# Access Compliance Report

## Public Rights-of-Way

Intersection ID: N/A	Main Street: CALLEY_GLENN_LN	Cross Street: FIVE_KNOLLS_DR	Location: SE
ADA ID: 17F9CD425CA2	Ramp Type: PerpDiag	Initial Pass/Fail: Fail	Overall Compliance: No
Severity Score: 8.75			
Codes/Mitigation Info/Possible Solution		Field Measurements/Component Compliance

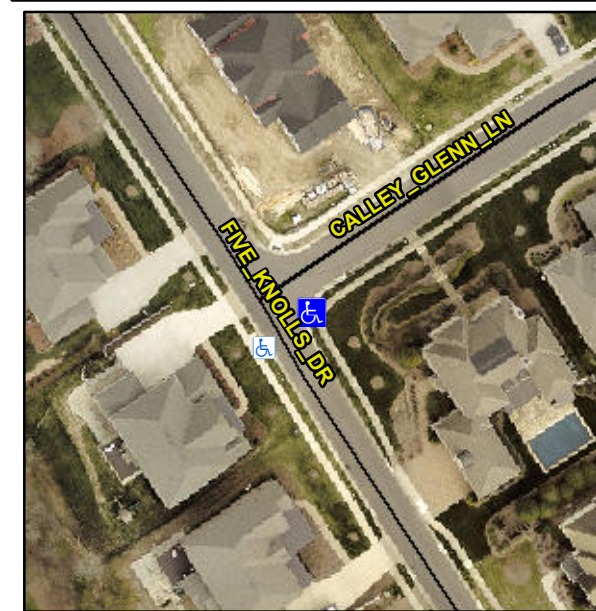
**Not Found, R304.5.1**

Compliance	Description	Data	Compliance	Description	Data
N/A	Ramp Length (in)	47.5	Yes	Ramp Slope (%)	5.0
No	Ramp Width (in)	46.0	Yes	Ramp XSlope (%)	2.0
N/A	Flare Type LT	N/A	N/A	Flare Type RT	N/A
N/A	Flare Slope LT (%)	N/A	N/A	Flare Slope RT (%)	N/A
N/A	Flare Traversable LT?	N/A	N/A	Flare Traversable RT?	N/A
N/A	Landing Length (in)	N/A	N/A	DWS Provided?	N/A
N/A	Landing Width (in)	N/A	N/A	DWS Contrast?	N/A
N/A	Landing Slope (%)	N/A	N/A	DWS Length (in)	N/A
N/A	Landing X Slope (%)	N/A	N/A	DWS Full Width?	N/A
N/A	Landing Curb? (Y/N)	N/A	N/A	DWS Offset (in)	N/A
N/A	Shared Landing?	N/A			
N/A	Gutter Ponding?	N/A	N/A	Gutter Slope (%)	N/A
N/A	Gutter Lip Ht (in)	N/A	N/A	Gutter X Slope (%)	N/A
N/A	Painted X Walk1?	No	N/A	Painted X Walk2?	No
	X Walk 1 Direction	To N		X Walk 2 Direction	To W
N/A	X Walk 1 Width (in)	N/A	N/A	X Walk 2 Width (in)	N/A
	X Walk 1 Slope (%)	1.7		X Walk 2 Slope (%)	1.8
	X Walk 1 X Slope (%)	2.2		X Walk 2 X Slope (%)	1.5

**Remove & Replace Curb Ramp With Two New Directional Ramps or Equivalent.**
